**Illinois Tollway Standard Drawings Revisions**

| Section L    |   | Fiber Optic           |  |
| Standard     | Modification Summary  | Effective: 03-01-2025 |  |
| <b>L1-07</b> | <b>Fiber Optic System Typical and Drawings</b>  |                       |  |

| VERSION:<br>2025-03 | STANDARD:<br>L1-07 | SHEET:<br>1 OF 15 |

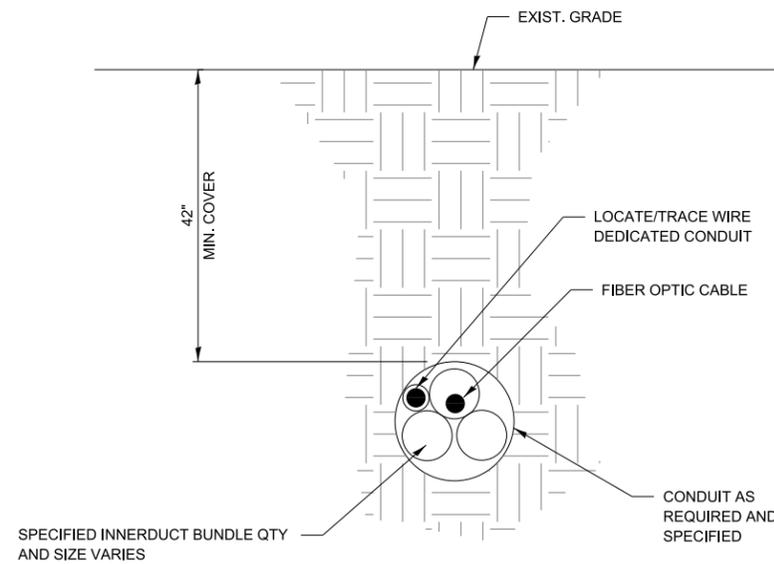
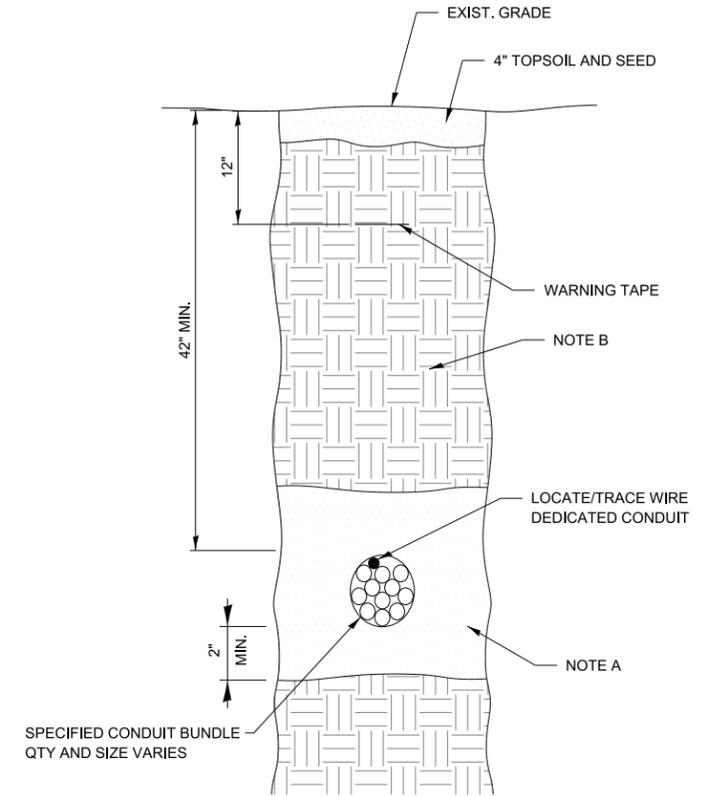
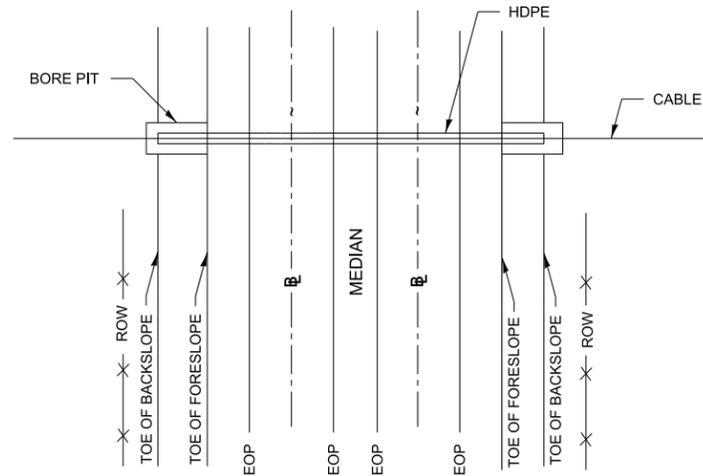
| Section L    |   | Fiber Optic           |  |
|--------------|---|-----------------------|--|
| Sheet 1      | Remove "or compression" from Note 3.  |                       |  |
|              | Added "If conduit is not under the maintenance of the contractor, the contractor shall coordinate with the Illinois Tollway Fiber Optic Maintenance Vendor to perform the cutting & splicing of conduit" to Note 3. |                       |  |
|              | Updated all details to show locate/tracer wire inside its dedicated conduit.  |                       |  |
|              | Updated Note 5 to state "locate/trace wire shall be installed inside of it's dedicated conduit in continuous lengths without splicing".   |                       |  |
|              | Changed callout in on the "Bored Conduit With Fiber Optic Cable..." detail from "conduit as specified" to "conduit as required and specified".  |                       |  |

VERSION: 2025-03      STANDARD: L1-07      SHEET: 2 OF 15

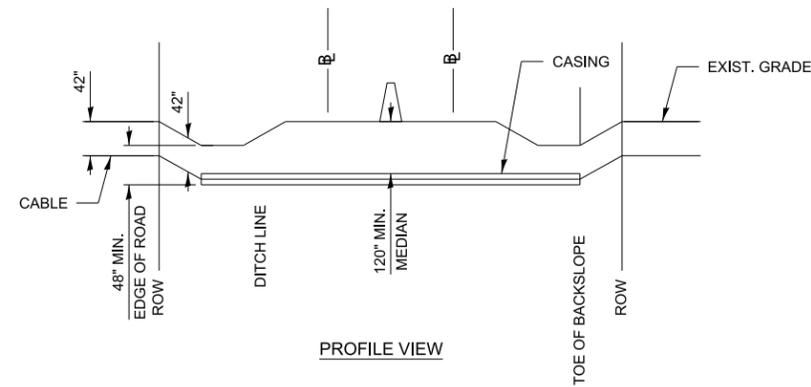
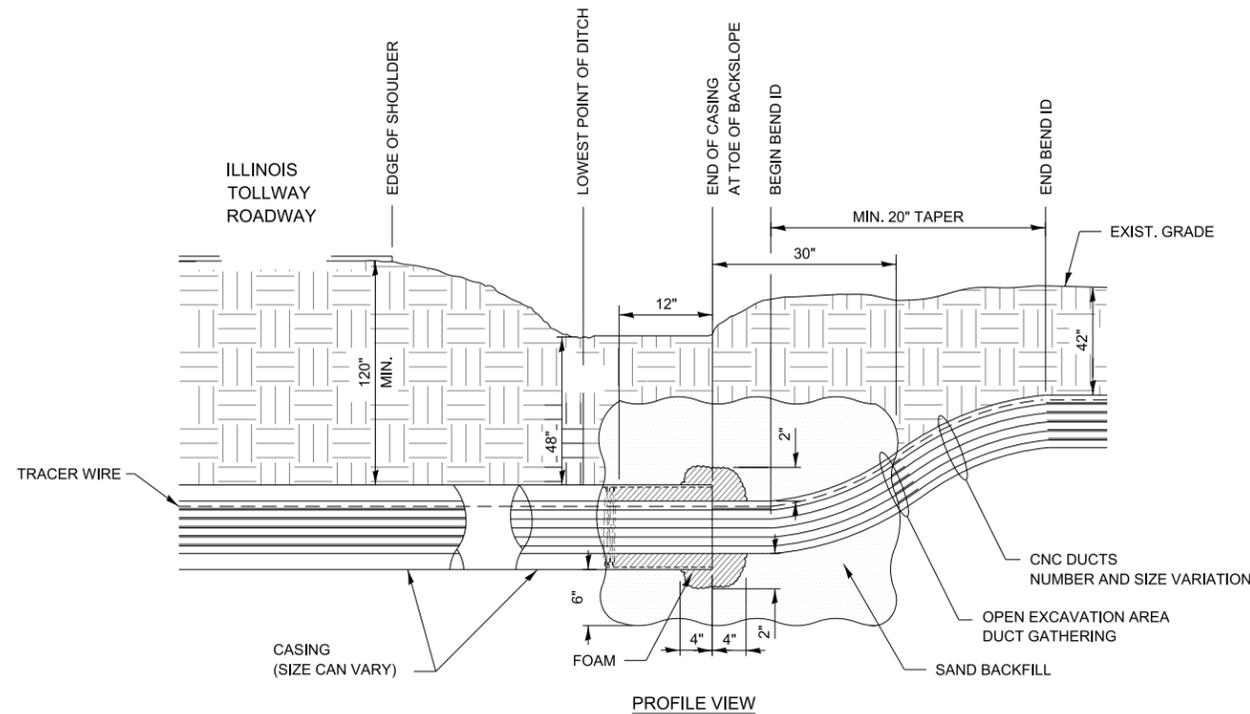
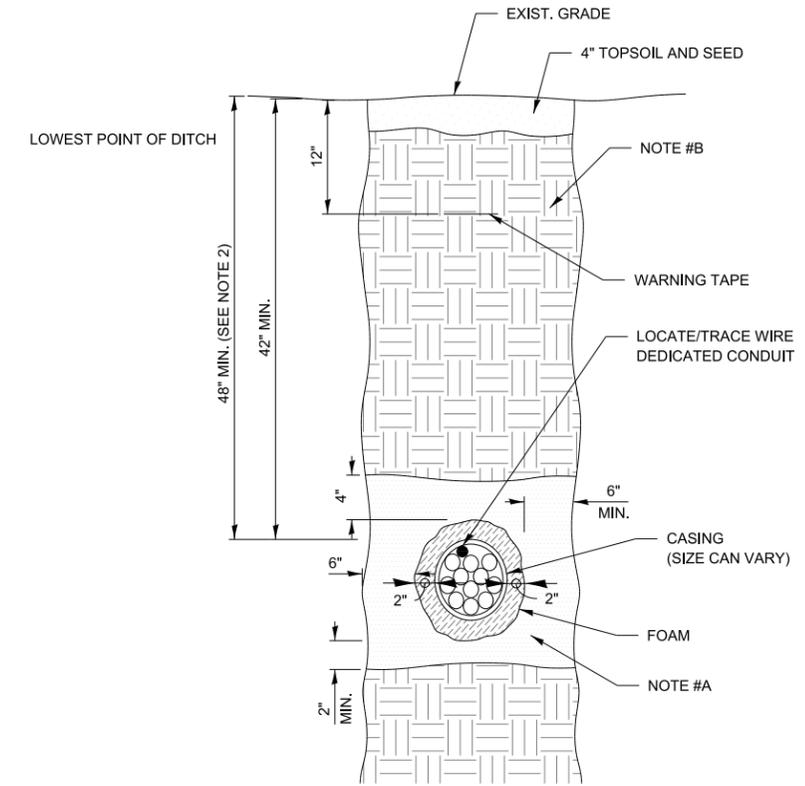
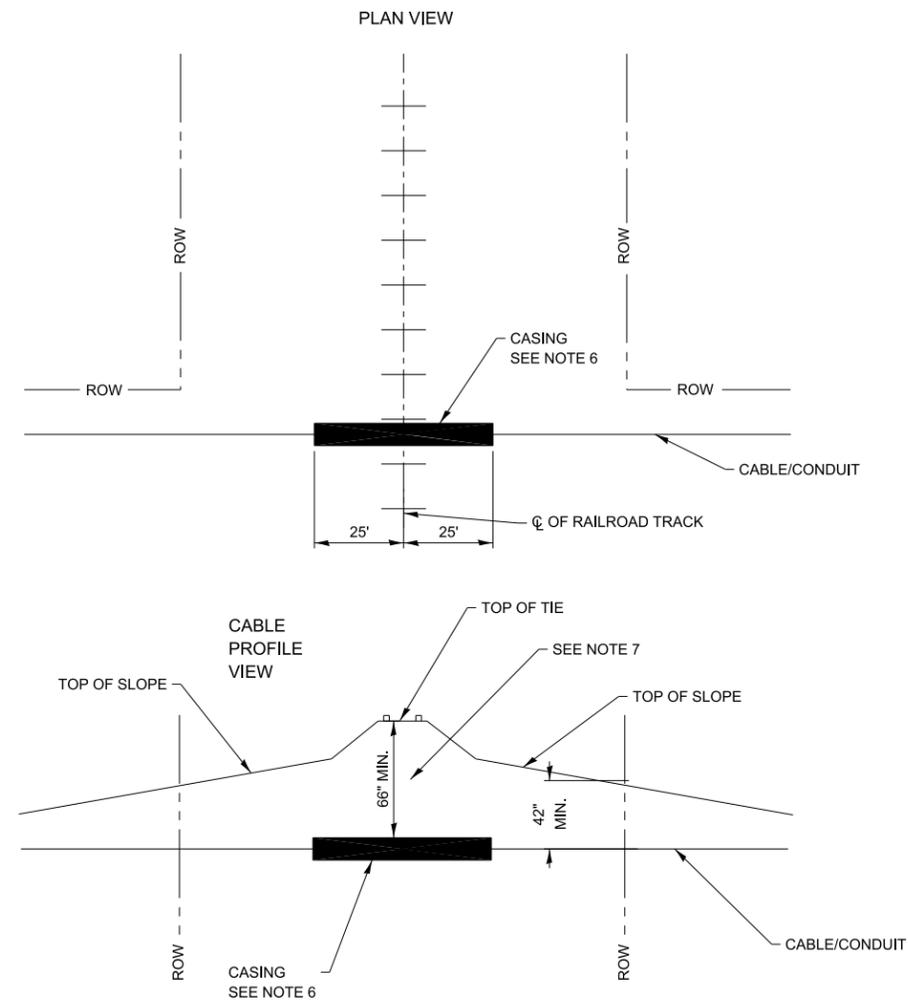
| Section L    |   | Fiber Optic           |  |
|--------------|---|-----------------------|--|
| Sheet 2      | Remove "or compression" from Note 4.  |                       |  |
|              | Added "If conduit is not under the maintenance of the contractor, the contractor shall coordinate with the Illinois Tollway Fiber Optic Maintenance Vendor to perform the cutting & splicing of conduit" to Note 4. |                       |  |
|              | Added "Foam plug shall extend inside of casing 12" from end of casing. Cap the casing by placing the foam around the casing, creating an 8" "mushroom" shape plug" to Note 8.                                       |                       |  |
|              | Updated "Profile View" detail to show the tracer wire inside of the conduit.  |                       |  |
|              | Split the 8" measurement into two 4" measurements for clarity on the "Profile View" detail.   |                       |  |
|              | Updated "Side View" detail to show locate/tracer wire inside its dedicated conduit.   |                       |  |
|              | Reposition the 6" measurement of sand fill from top of casing to bottom of casing in the profile view.  |                       |  |

| VERSION:<br>2025-03   | STANDARD:<br>L1-07 | SHEET:<br>4 OF 15 |

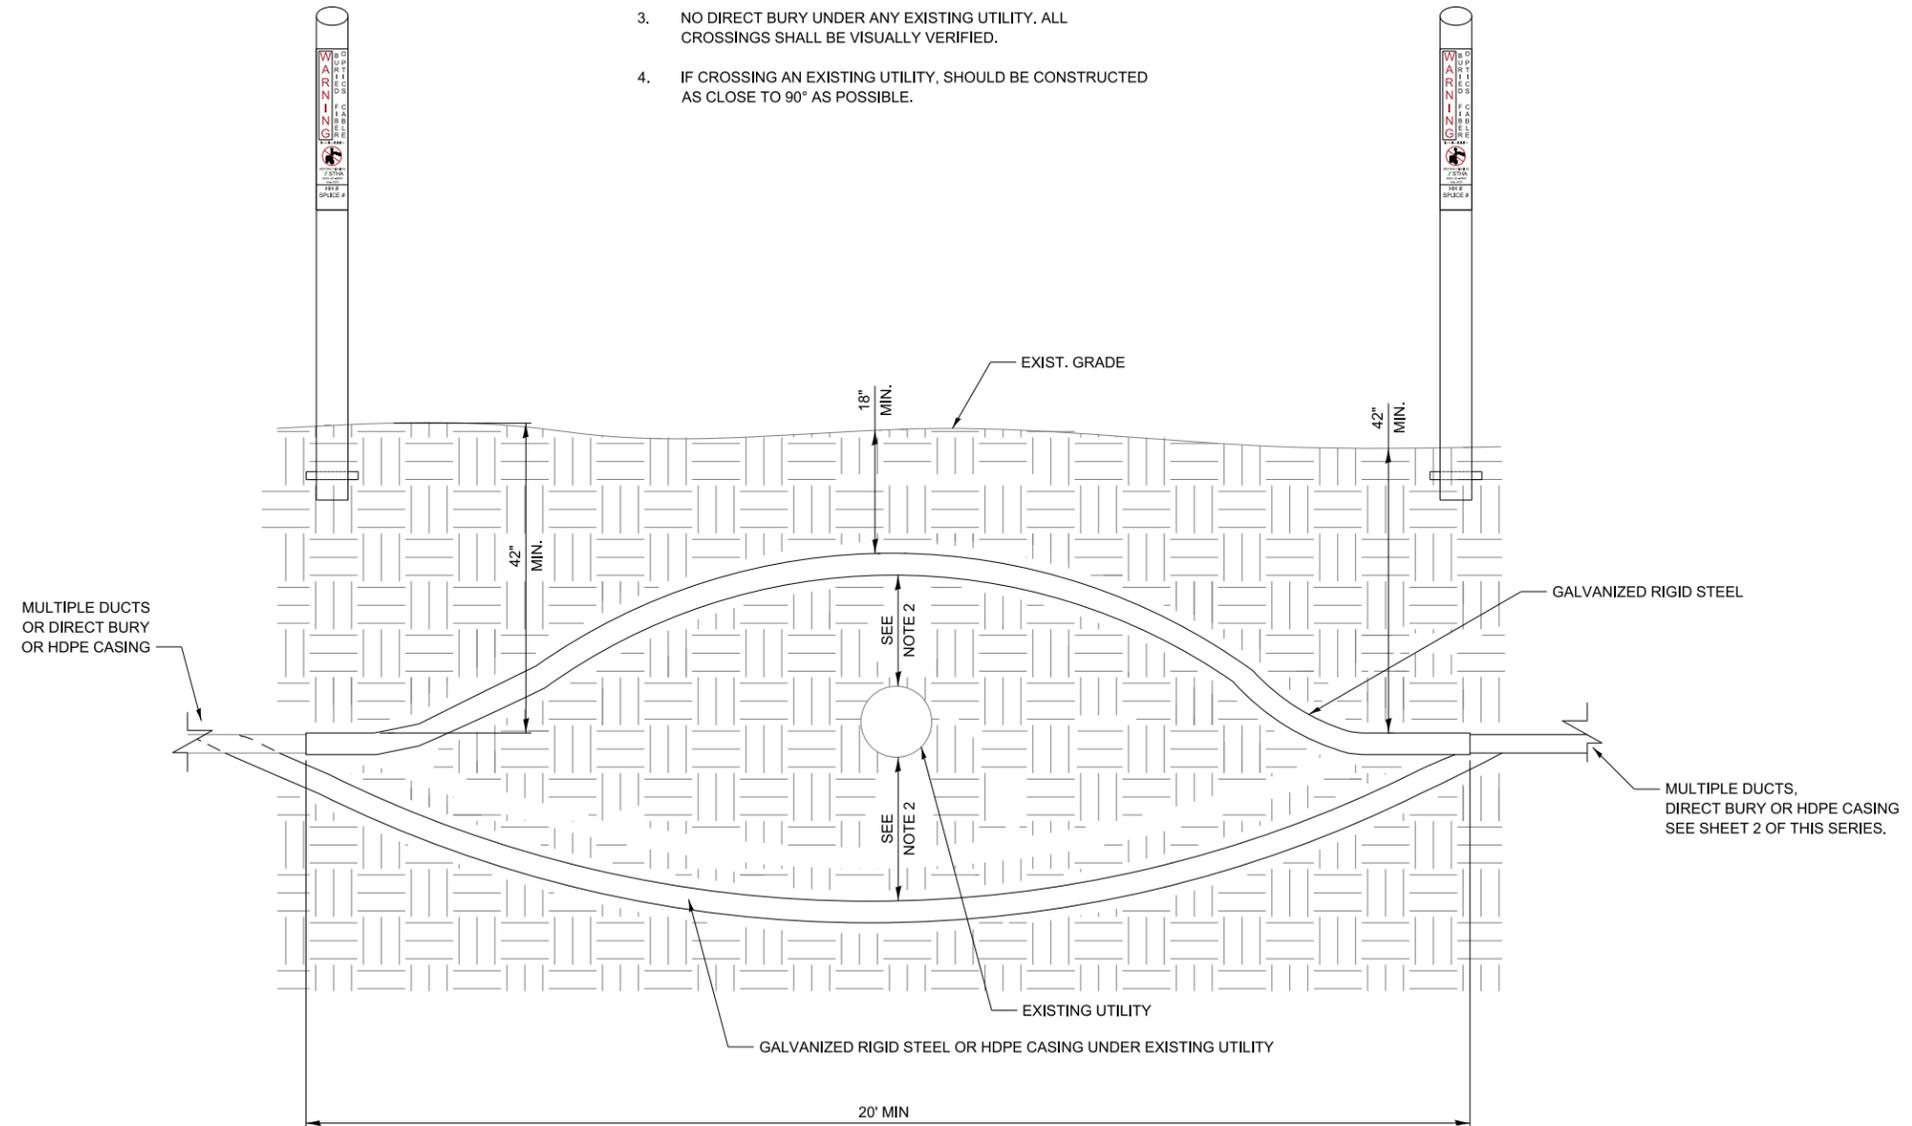
| Section L    |   | Fiber Optic           |  |
|--------------|---|-----------------------|--|
| Sheet 4      | Added "for oil or gas utility, a minimum of 18in to 24in separation between pipe and conduit (or as required by utility owner)" to Note 2.  |                       |  |
|              | Removed note that stated "minimum 18" to 24" separation for oil, gas utility between pipe and conduit (or as required by utility owner).  |                       |  |
|              | Updated detail to show warning post.  |                       |  |
|              | Removed locate wire from detail.  |                       |  |
|              | Replaced "12" Min" with "See Note 2" on detail.   |                       |  |

| VERSION:<br>2025-03   | STANDARD:<br>L1-07 | SHEET:<br>5 OF 15 |

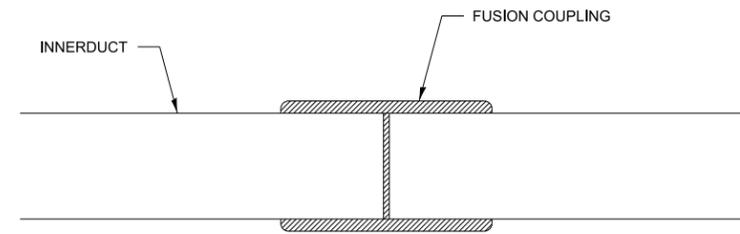
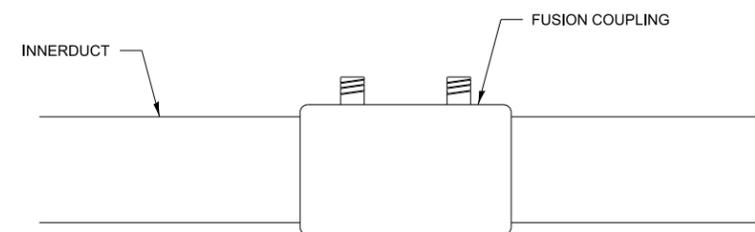
| Section L    |   | Fiber Optic           |  |
|--------------|---|-----------------------|--|
| Sheet 5      | Removed the "compression coupling" detail.  |                       |  |
|              | Removed Note 2 from general notes.  |                       |  |
|              | Removed "new" from Note 1.  |                       |  |

**36"x60" HANDHOLE  
2 SECTION SPLIT LID  
LESS THAN 5 DUCTS**

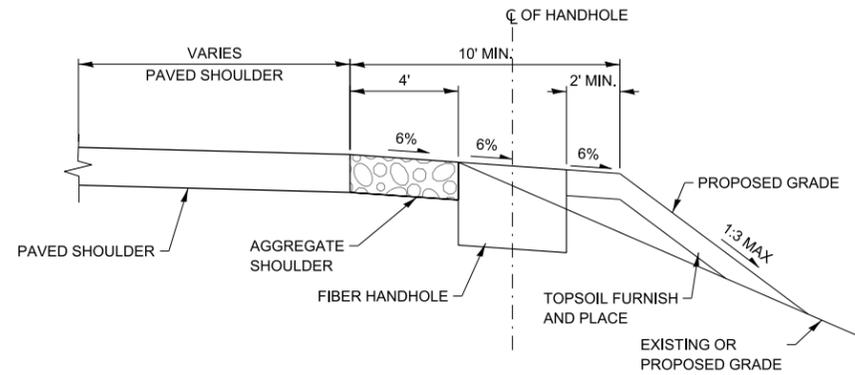
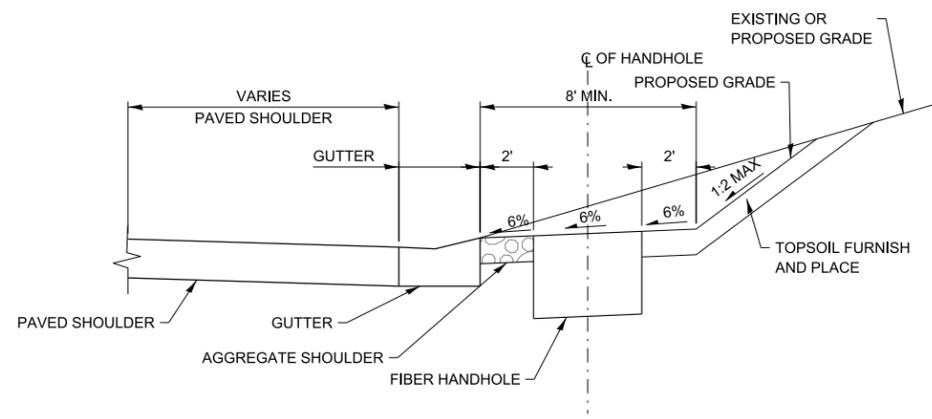
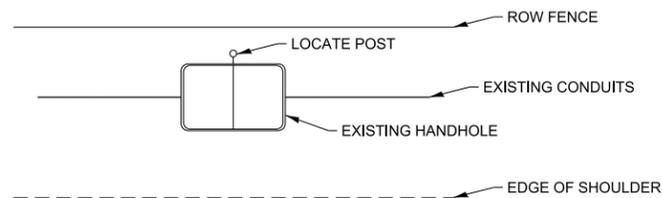
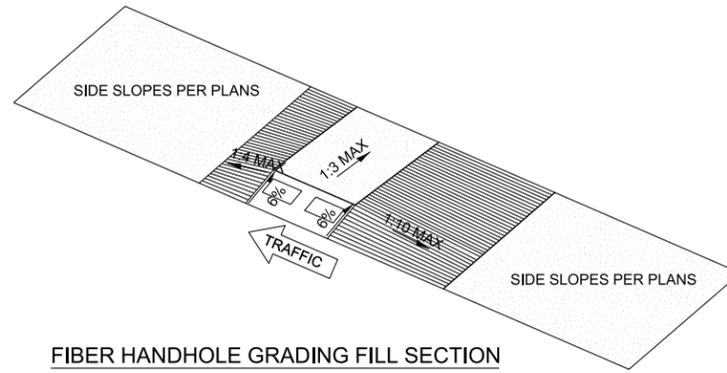
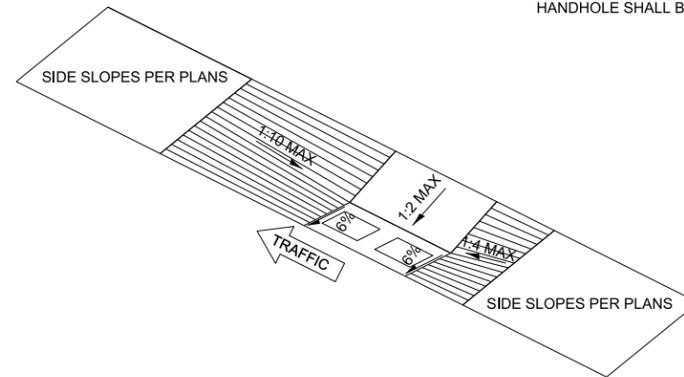
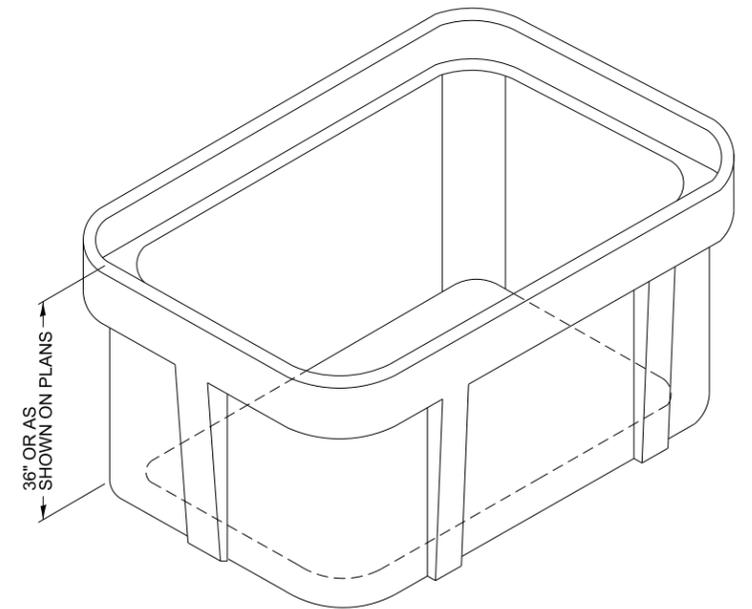
| Section L    |   | Fiber Optic           |  |
|--------------|---|-----------------------|--|
| Sheet 6      | Removed the "48"x72" Handhole" detail.  |                       |  |
|              | Added details for installing a handhole on a slope.   |                       |  |
